STEVENS FAMILY SUBDIVISION

APPLICATION NUMBER 3 DATE August 17, 2017

DETAIL SITE PLAN

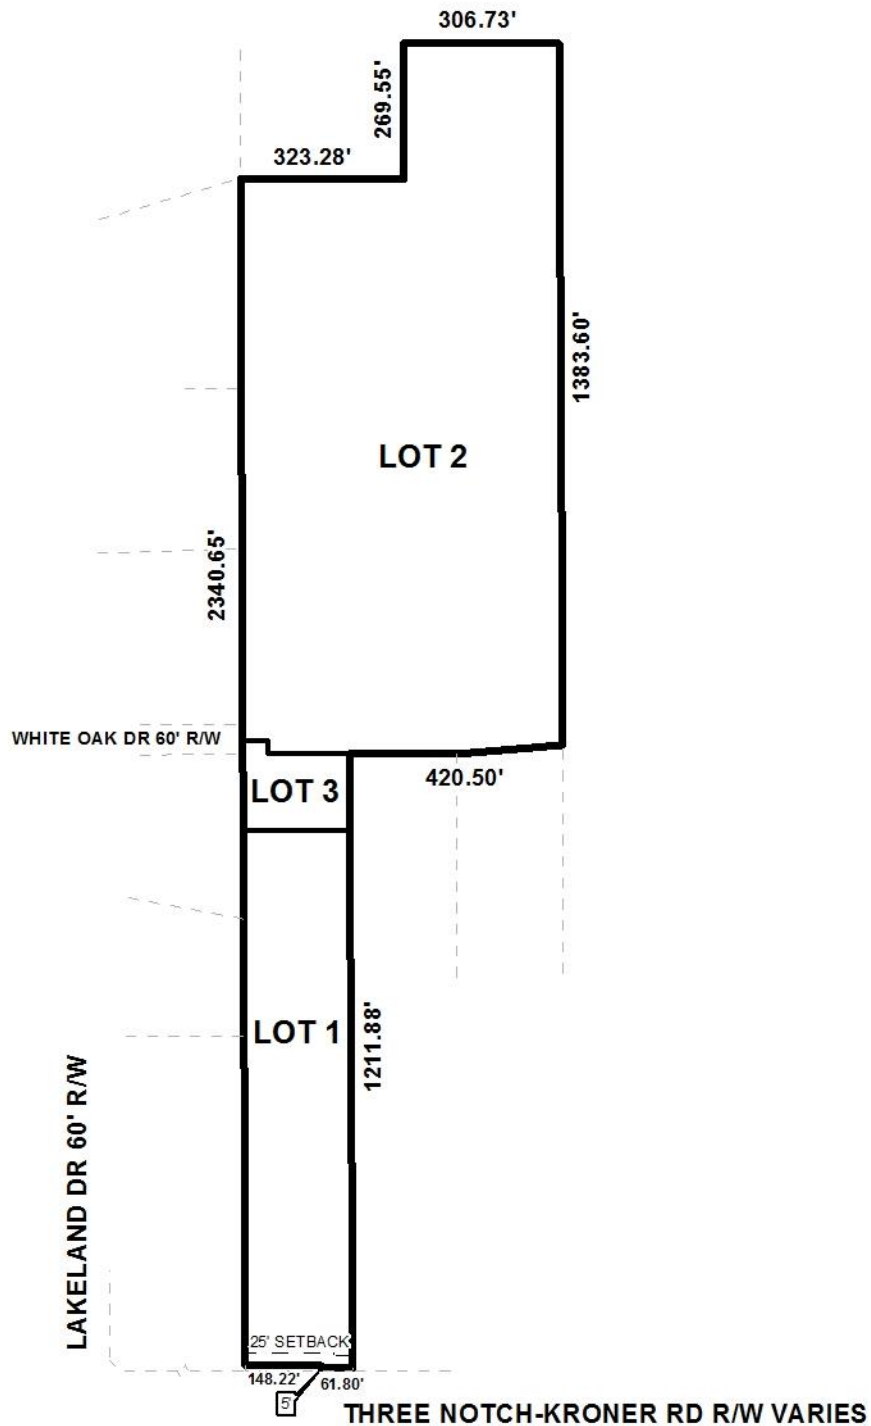
Proposed Lot 1 has 210.02'± of frontage on Three Notch Kroner Road, a planned major street requiring a 100' right-of-way width according to the most recently adopted Major Street Plan; and proposed Lots 2 and 3 are irregularly shaped with 35' and 25' of frontage at the terminus of White Oak Drive, respectively, an unpaved minor street without curb and gutter requiring a 60' right-of-way width. The preliminary plat illustrates sufficient rights-of-way along both frontages therefore no additional dedications should be required; however, since White Oak Drive is substandard in terms of roadway width and surfacing, a note should be required on the Final Plat stating that there shall be no future subdivision of Lots 2 and 3 until White Oak Drive is improved in width and paved in asphalt to Mobile County Engineering standards.

It should be noted that the width of the portion of Lot 1 along which it has street frontage is large enough to be potentially re-subdivided and, in accordance with Section V.D.3. of the Subdivision Regulations, is not exclusive of unusable land thus contributing to a maximum depth more than 3.5 times the width of the lot at its potential building line. Conversely, the widths of the portions of Lots 2 and 3 along which they have street frontage are small enough to contribute to similar width-to-depth ratios at their potential building lines. Coupled with their irregular shapes, it should be pointed out that such lot designs are generally discouraged by the Subdivision Regulations, the exceptions being family subdivisions similar to the application at hand, or the approval of lots located where varied and irregularly-shaped lot designs are common, and the informality of design is consistent with other lots in the vicinity. Planning Commission approval of a neighboring subdivision in 2007 with similar width-to-depth ratios may facilitate approval of this request, but a waiver of Sections V.D.1. and V.D.3. of the Subdivision Regulations will

be required. Also, a note should be required on the Final Plat stating further re-subdivision of the lots will not be allowed until additional public street frontage is provided.

The 25' minimum building setback line is labeled for Lot 1, but not for Lots 2 and 3. As such, revision of the plat to illustrate the 25' minimum building setback line where each lot is at least 60' wide should be required, if approved.

As a means of access management, a note should be required on the Final Plat stating that Lot 1 is limited to two (2) curb cuts to Three Notch Kroner Road, and that Lots 2 and 3 are limited to one (1) curb cut each to White Oak Drive, with any changes in their sizes, locations or designs to be approved by Mobile County Engineering and conform to AASHTO standards.

- 1) placement of a note on the Final Plat stating that there shall be no future subdivision of Lots 2 and 3 until White Oak Drive is improved in width and paved in asphalt to Mobile County Engineering standards;

- 2) retention of the lot sizes in square feet and acres on the Final Plat, or provision of a table providing the same information;
- 3) revision of the plat to illustrate the 25' minimum building setback line where each lot is at least 60' wide;

- 4) placement of a note on the Final Plat stating Lot 1 is limited to two (2) curb cuts to Three Notch Kroner Road, and Lots 2 and 3 are limited to one (1) curb cut each to White Oak Drive, with any changes in their sizes, locations or designs to be approved by Mobile County Engineering and conform to AASHTO standards;
